*CITY OF BEACON*  
*One Municipal Plaza - Courtroom*  
*BEACON, NEW YORK 12508*  
*Phone (845) 838-5002 Fax (845) 838-5026*

The Zoning Board of Appeals will meet on **Tuesday, September 17, 2019** in the Municipal Center Courtroom. A training work session will take place at 7:00 p.m. and the regular meeting will begin immediately thereafter, but not later than at 7:30 PM.

Re: Application for Area Variances – Mixed-Use Development – Supplemental Submission  
Premises: 23-28 Creek Drive, Beacon, New York (Tax ID: 6054-37-037625)

We have received the comments on the Traffic Impact Study for the 23-28 Creek Drive development as presented by Creighton Manning in their April 4, 2019 letter to the Planning Board. The following provides specific responses to each of the comments presented in that letter.

**Site Plan**

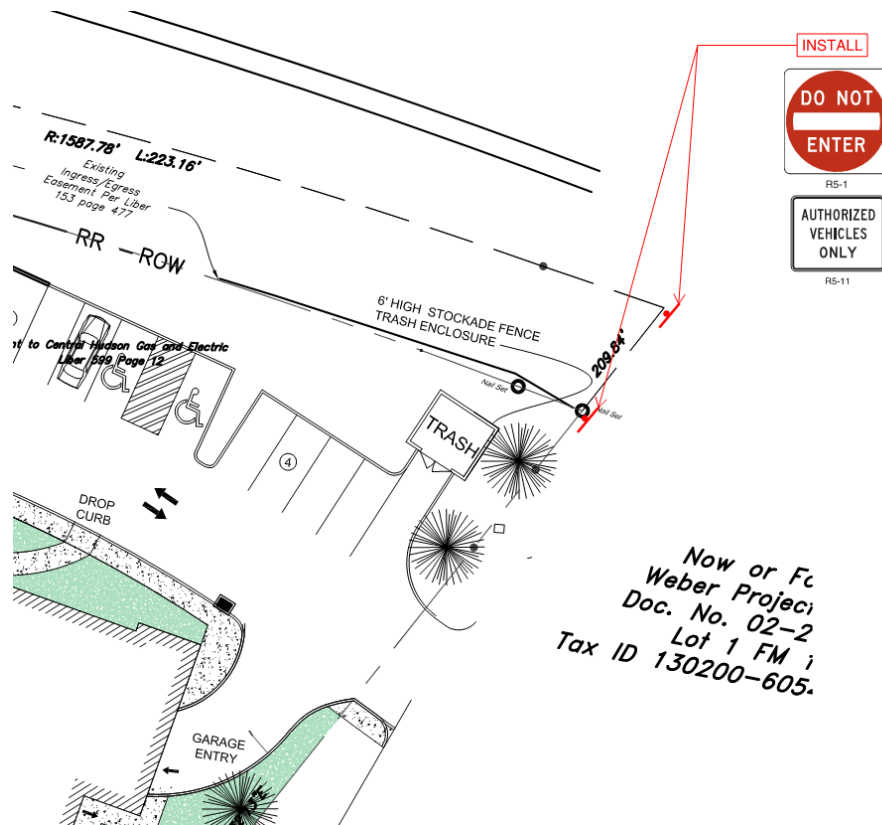
1. CM recommends that the applicant consider adding crosswalks and ramps at the internal intersection between 7-11 Creek Drive and 23-28 Creek Drive to enhance pedestrian connectivity between buildings, as shown below:

***Response: Comment noted. A crosswalk and sidewalk curb ramps will be added on the west side of the intersection. A crosswalk on the east side would lead to the proposed trash enclosure for 23-28 Creek Drive and therefore does not seem to be an appropriate location for a crosswalk. See exhibits in Item No. 2 below for proposed location of this crosswalk.***
